68 Deering St., BP#2014-02509

remaining questions:

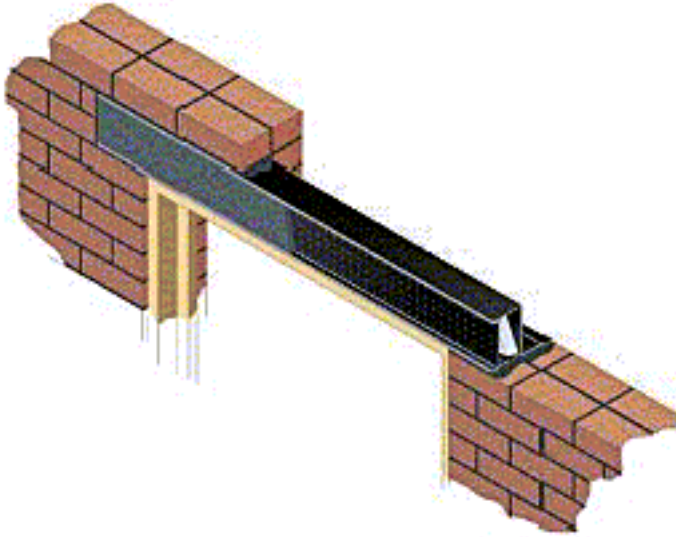
-Diagram of the load bearing path at all new Engineered beams,

including any new footings and columns in the basement

-Provide the engineered lumber specifications sheets for this specific job (none of the other walls being removed require headers. They are not load bearing)

-Provide the wall infill details, ie. a section or plan view of materials

-Provide ceiling repair or replacement materials

The original floor plan with wall removal and LVL shows 3 locations for beams, bathroom, kitchen and bedroom. Please clarify this and the load bearing support of these beams.

Steel I-beam for 40" span in bathroom to solid brick wall. I beam carries the upper load with force paths going into the brick supporting the beam. The beam is supported by 6" of brick on either side. Door header in the brick will either be a standard 4" I beam or back to back steel "c" channels. All steel is 1/4" thick

Only steel I-beam. On the first floor, only the wall in the bathroom is weight bearing.

Infill is paper faced 2x6" r=19 pink fiberglass. The paper face will be stapled to the framing lumber.

Double layer of standard 5/8 fire code sheetrock, skim coat of plaster with paper faced 2x6" r=19 pink fiberglass

insulation

After further inspection, it is evident that the walls in the kitchen, bedroom are not load bearing. These will not require header supports to remove.

The kitchen is moved to the interior wall to be closer to the existing plumbing.
